CHEMCLENE CORPORATION  
CORRECTIVE ACTION  
FACILITY INVESTIGATION  
CORRESPONDENCE

GROUND-WATER RETRIEVAL PLAN  
FOR THE  
FORMER DISPOSAL AREA

SUBJECT: Comments on Ground-Water Retrieval Plan for the  
Former Disposal Area Chemcene Corporation,  
Malvern, PA

WORK PLAN  
TO COMPLETE  
REMEDIAL INVESTIGATION  
AND  
FEASIBILITY STUDY  
FOR THE  
MALVERN TCE SUPERFUND SITE

Figure 3 - Map showing the location of all wells to be monitored during the Ground-water Retrieval to be undertaken at the former disposal area.

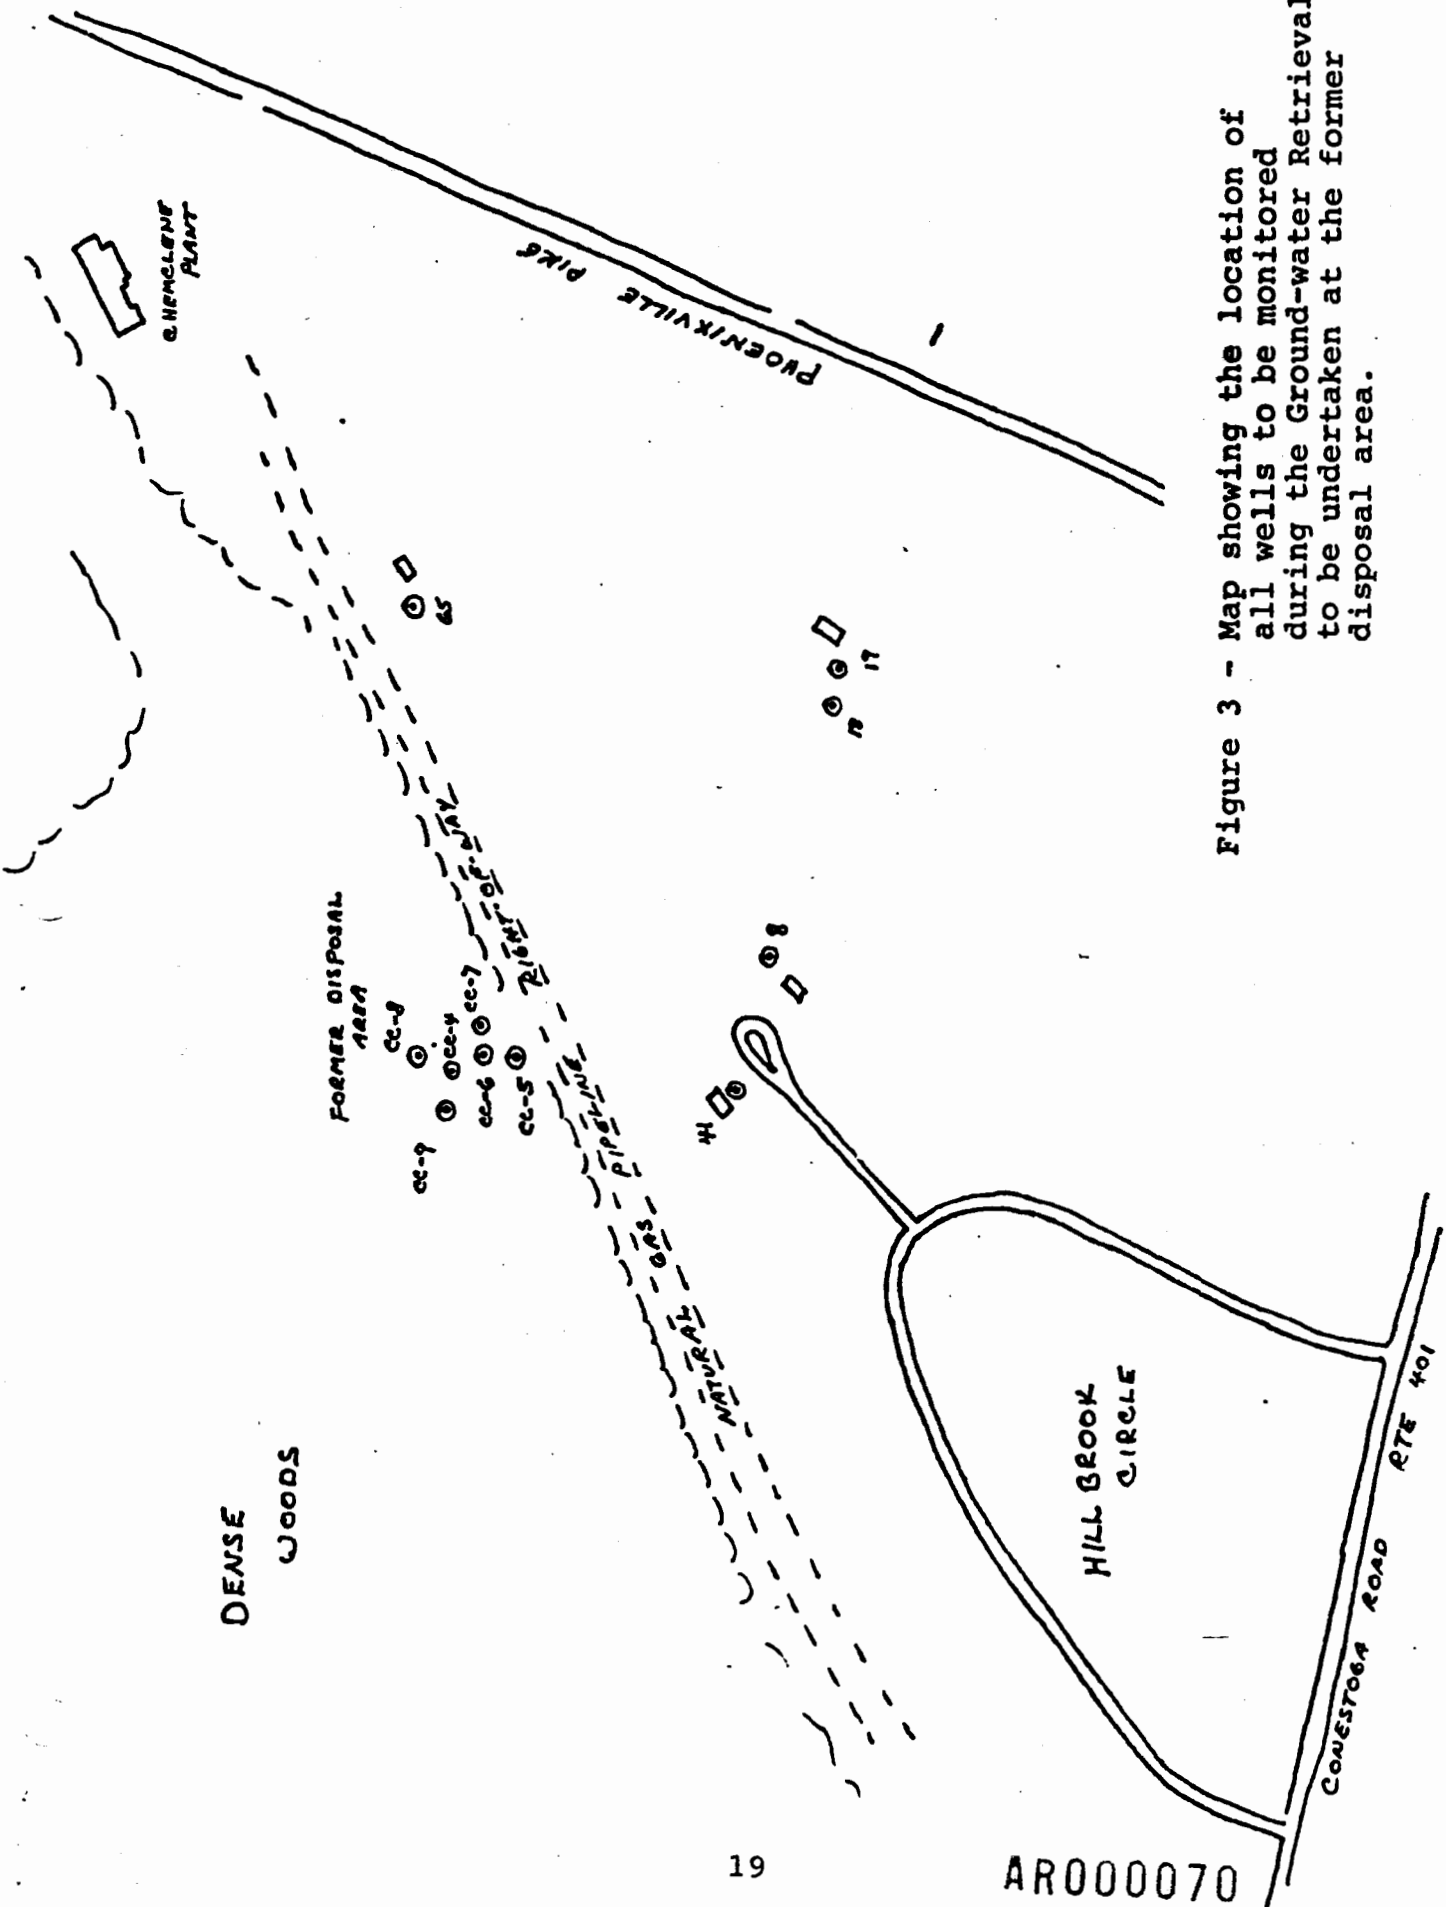
- D. Design and construction details of all recovery and monitoring wells must be provided to the Department.
- E. To properly delineate the extent of the existing contaminant plume and to monitor any effects that the groundwater recovery/treatment operation may have on areas downgradient from the disposal and plant sites, it is highly recommended that provisions be made to install a monitoring well located downgradient (i.e., east-northeast) from Chemelene between the plant and the quarries. The location of this well can be discussed with the DER and EPA.

- G. The Department highly recommends that additional wells be included in the proposed groundwater sampling/monitoring plan. Such locations should include private wells both within and beyond the current extent of groundwater contamination. This will help determine both the effectiveness of the groundwater recovery/treatment system and the migration of the contaminant plume.

Figure 2 - Map showing the location of the proposed retrieval well (CC-6), existing and proposed monitoring wells (CC-1, etc.) and shallow monitoring wells P-1, etc.

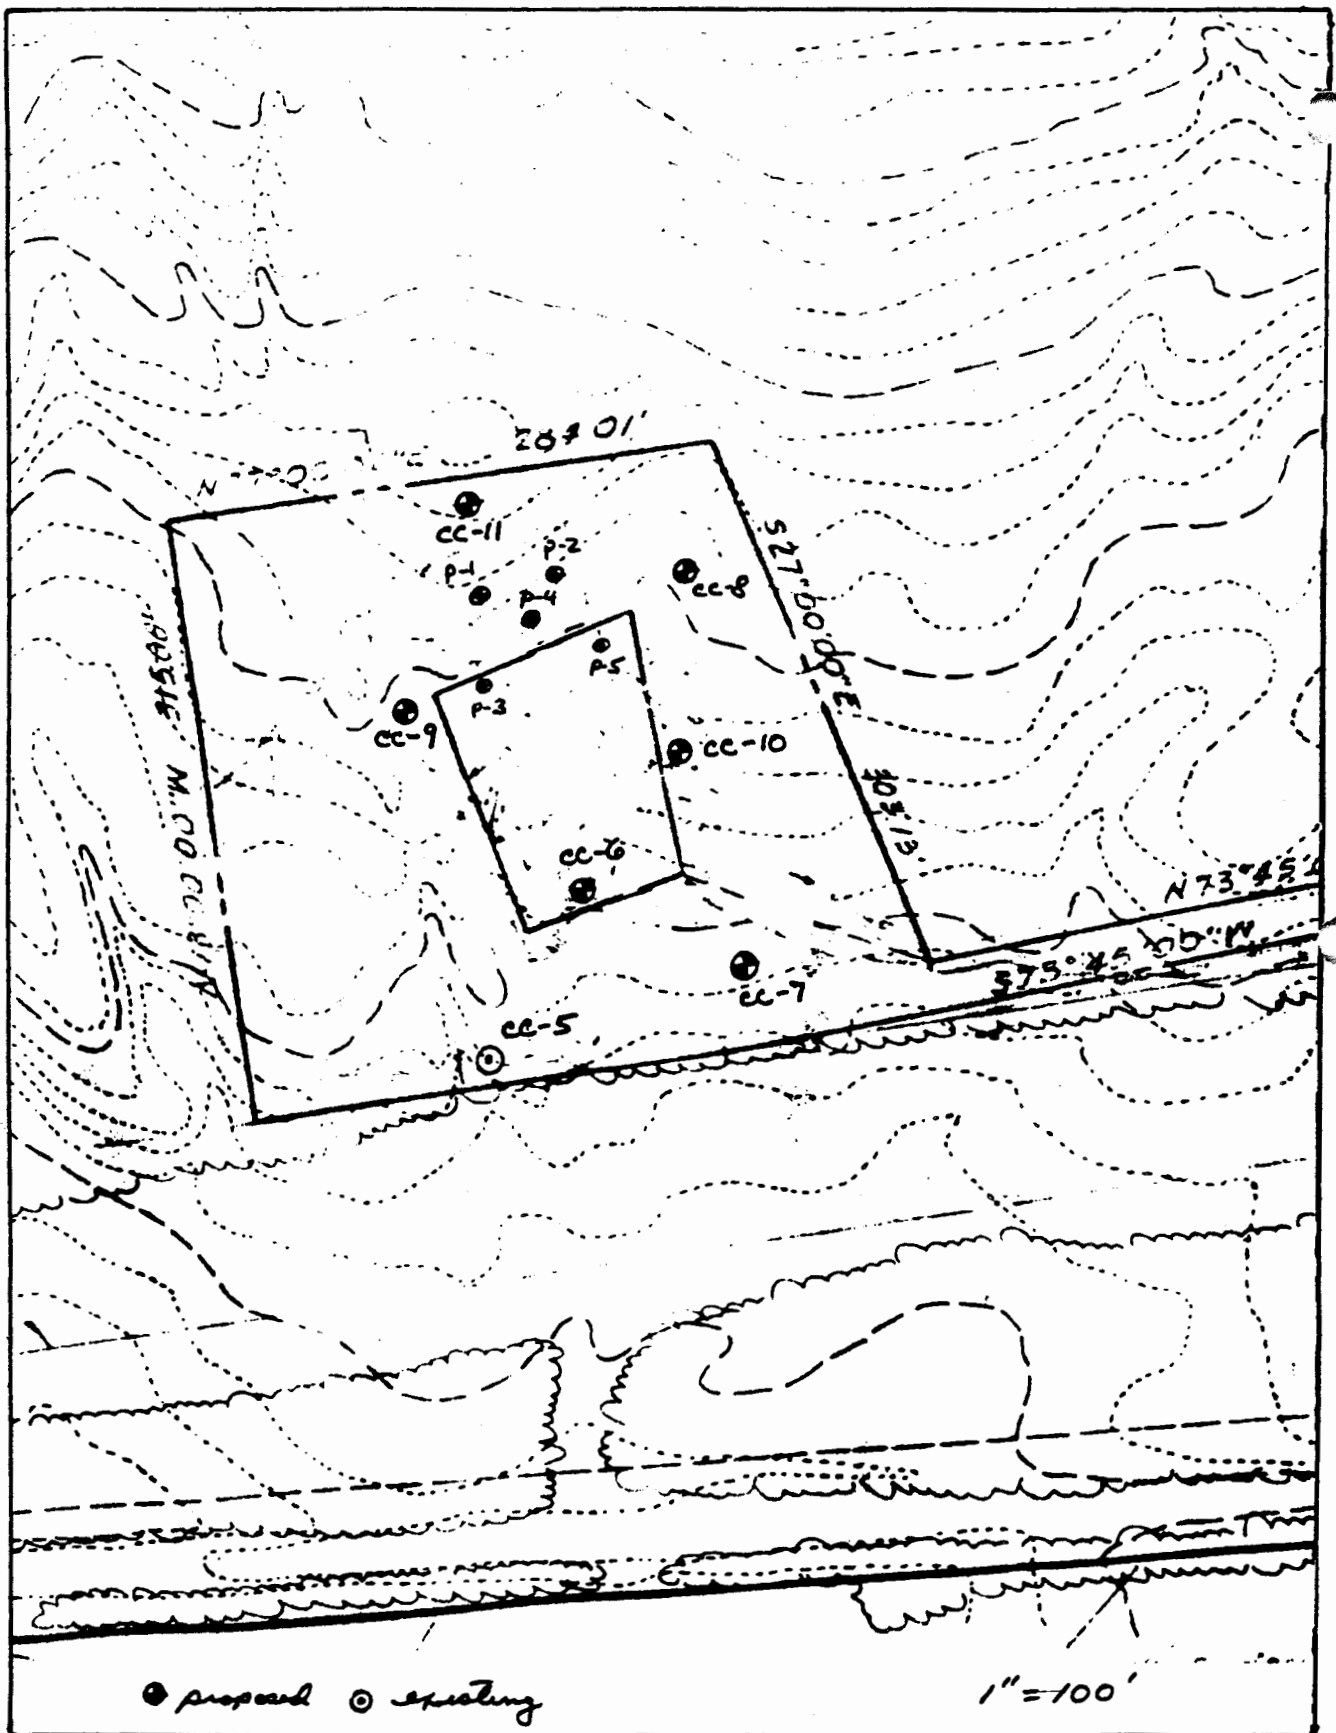
3.1.6 Locate and Construct Retrieval Well - As Figure 2 indicates, the tentative location of a retrieval well (CC-6) has already been selected. The actual location will be chosen following a review of fracture trace maps and geophysical survey results. It is intended that this well produce 10 to 30 gpm so its location on a fracture system is important. The retrieval well will be 6 inches in diameter and drilled to a depth of approximately 100 feet or until the first major water bearing zone is encountered. The well will be developed with cable tool equipment so as to minimize the problems associated with disposing of contaminated water. The well will be used for various testing purposes and would be converted to a permanent retrieval well if the results of the testing are successful and site conditions warrant the implementation of a containment and recovery program.

A system of seven deep monitoring wells is proposed. One of these will be existing Well CC-5. The tentative locations of the proposed monitoring wells are shown in Figure 2. The locations of the monitoring wells are also selected to be able to serve as observation points in the event that Well CC-5 or CC-10 is used as a recovery well instead of CC-6.
